71 Macquarie Street—Response to Submissions on Archaeology by Sydney Water and Heritage Council of NSW, May 2012

Executive Summary

Figure 1: Aerial photograph showing the lines of the Bennelong Drain (purple) in relation to 71 Macquarie Street (at the north centre part of the image). (Source: Sydney Water).

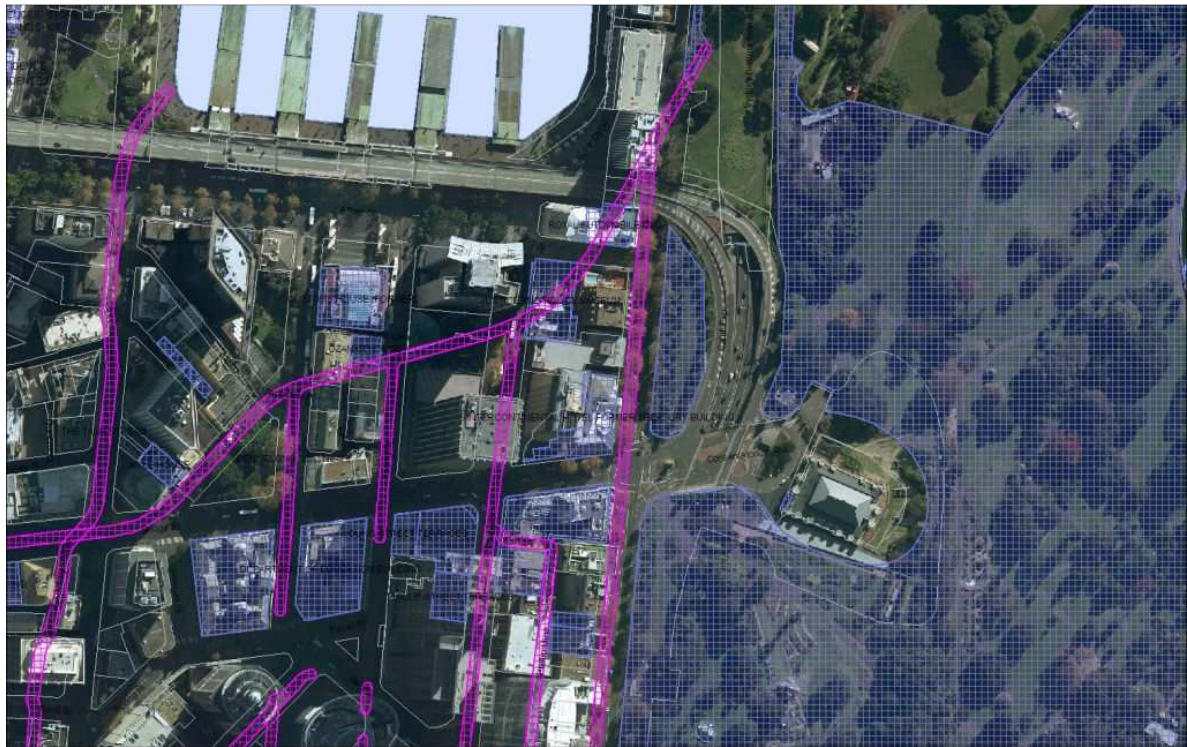
Sydney Water's response identifies that the development would be located over or very close to the Bennelong Oviform Stormwater Channel SWC 29 which is of local heritage significance. Sydney Water's position is that development should not extend over, or within one metre from the outside of, the stormwater channel¹. They have also stated that no new openings should be made in the early brick built oviform shaped stormwater channels and that they will require accurate drawings to ascertain the precise nature of any impacts or construction within the 1 metre zone around the drain.

Aerial photographs showing the location of the Bennelong Drain in relation to 71 Macquarie Street are shown in Figure 1. Sydney Water has indicated that the plans showing the location of the Bennelong Drain are indicative only and may not show the exact location of the drain. Mirvac have mapped the locations of the drains in relation to location of the proposed building (Figure 7).

GMLs response: A detailed Archaeological Assessment report would be prepared and the impact of any proposal on the drain would be assessed in a Heritage Impact Statement (HIS) and any other methods required by Sydney Water. Based on existing survey and Sydney Water plans no physical impacts are anticipated on the Bennelong Drain or within the one metre curtilage around it. However, in the event that physical impacts were to become necessary, Sydney Water's approval would be sought and any approval conditions, such as archival recording would be complied with.

The impact of any proposal would be assessed in a Heritage Impact Statement (HIS) and any other methods required by Sydney Water. No major changes are anticipated to the Bennelong Drain or within the one metre curtilage. However in the event that impact to the drain is required, following consultation and approval from Sydney Water, archival and photographic recording would be undertaken as per the recommended management as outlined on the Bennelong Stormwater Channel No 29 listing on the Heritage Branch website³, with a copy of the records lodged with Sydney Water archives and the NSW Heritage Office.

Figure 4: Plan of the British Tobacco Company Building (Source; Demolition and Excavation Scheme 'B' Modifications to Gallery Construction, Stephenson & Turner Architects, 1963).

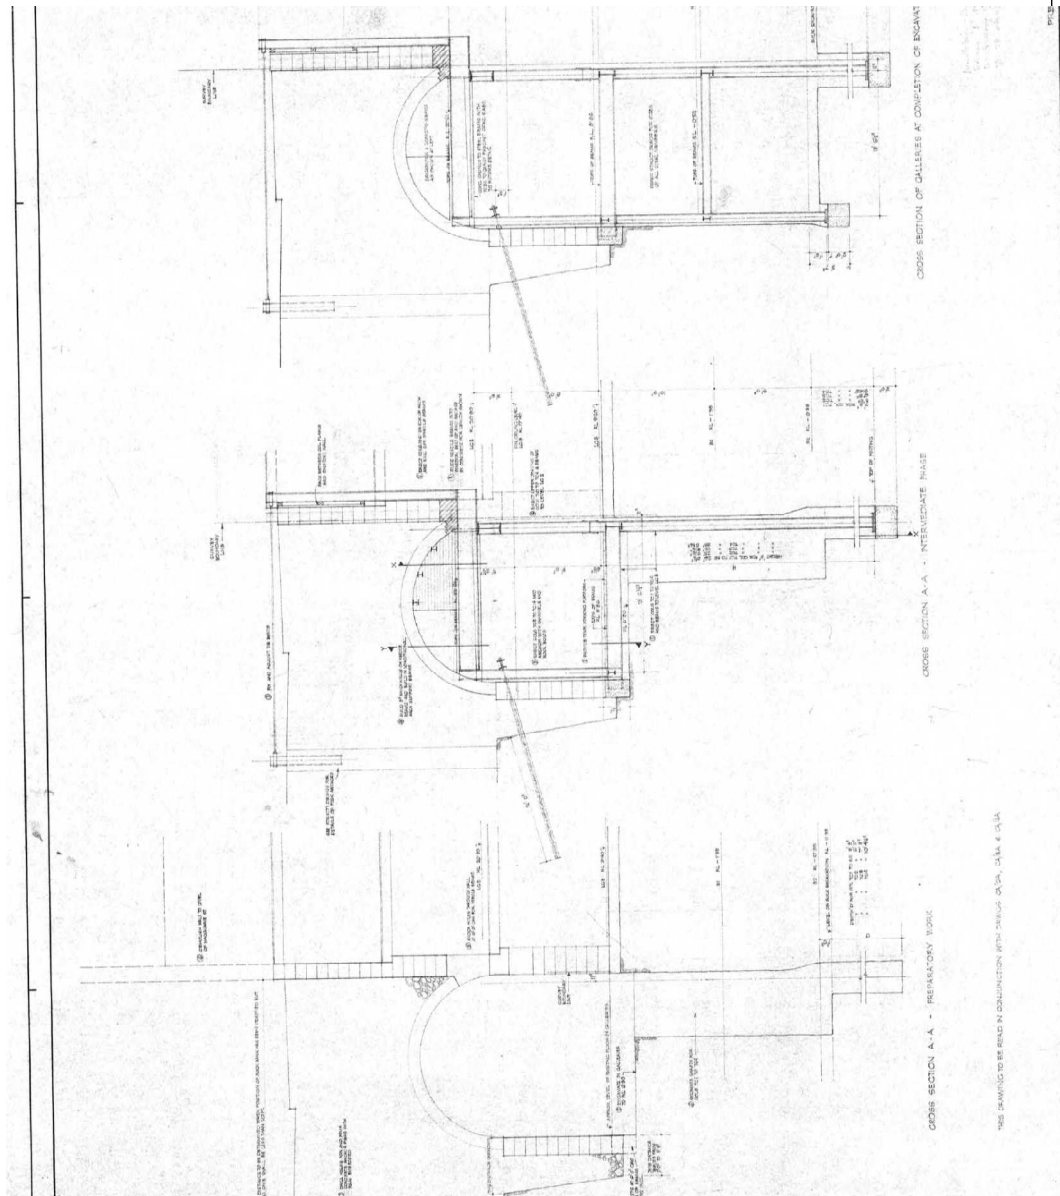
Based on results of the site visit on 4 April, it appears the arches of the sandstone gallery have been removed. Further, analysis of the historic plans of the sandstone arches reveals a demolition plan (Figure 4). It is likely that the sandstone arches were removed during demolition of the warehouses and construction of the present Amatil Building in the 1960s.

Figure 7: Plan showing the area of the former gallery (marked by 'Line of existing tower over') and proximity of the Bennelong Drain and buffer zone to 71 Macquarie Street. (Source: Hassell / Sydney Water Authority 2012).

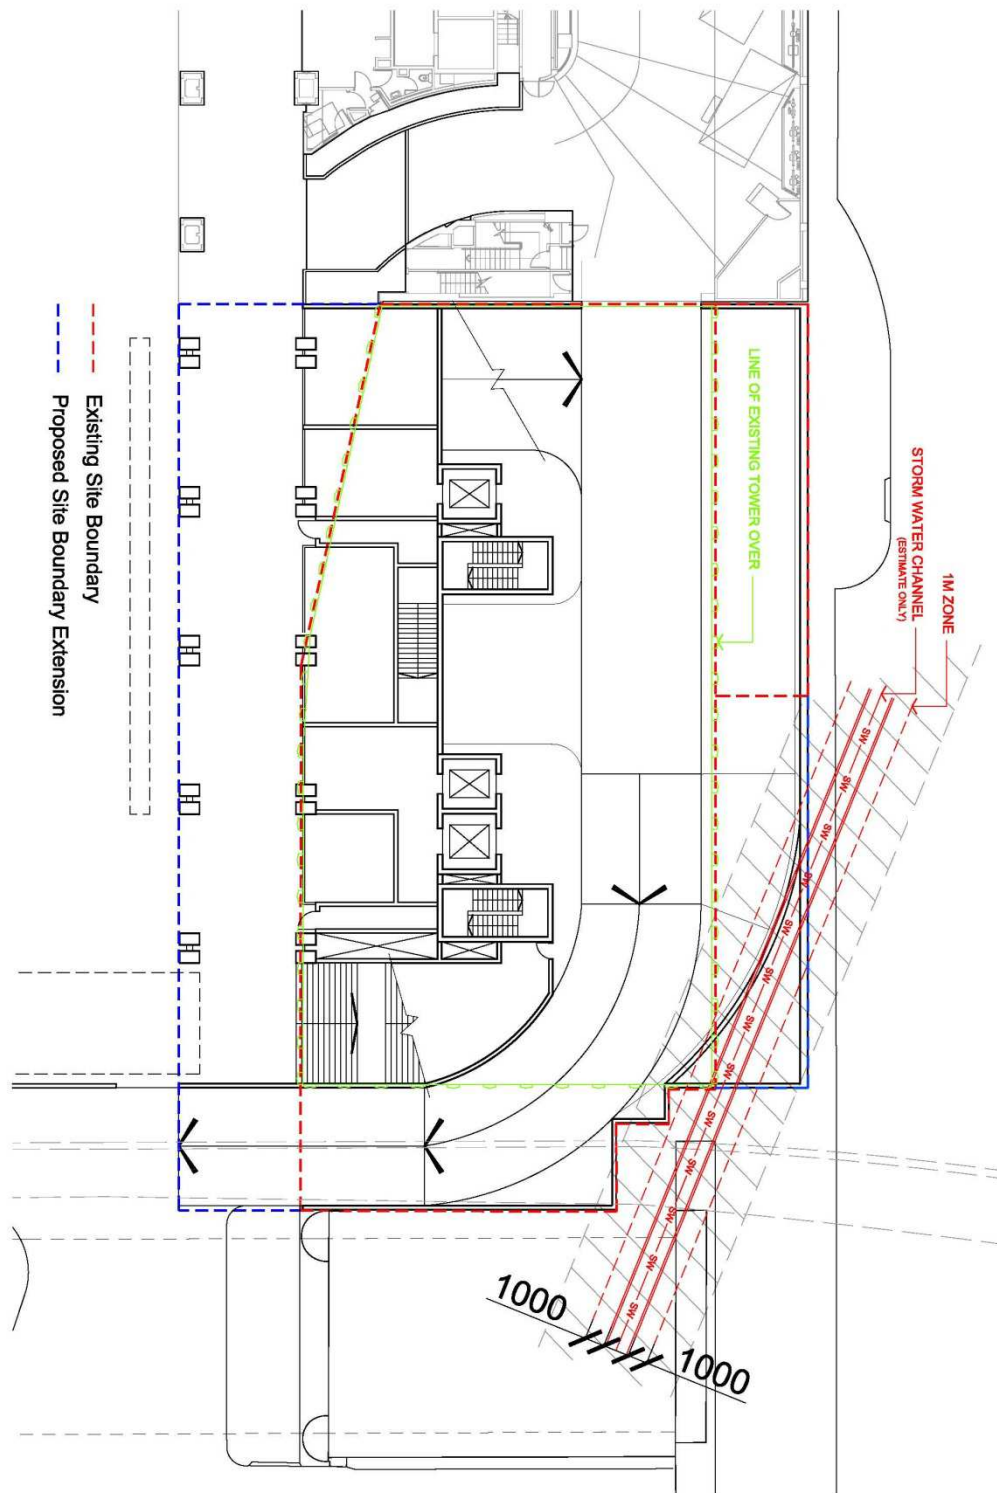
The space of the former gallery is presently used as a carpark in basement level one (Figure 5) and a storage space in the basement level two (Figure 6). Figure 7 shows this storage space and also the proximity of the Bennelong Drain to the present building.
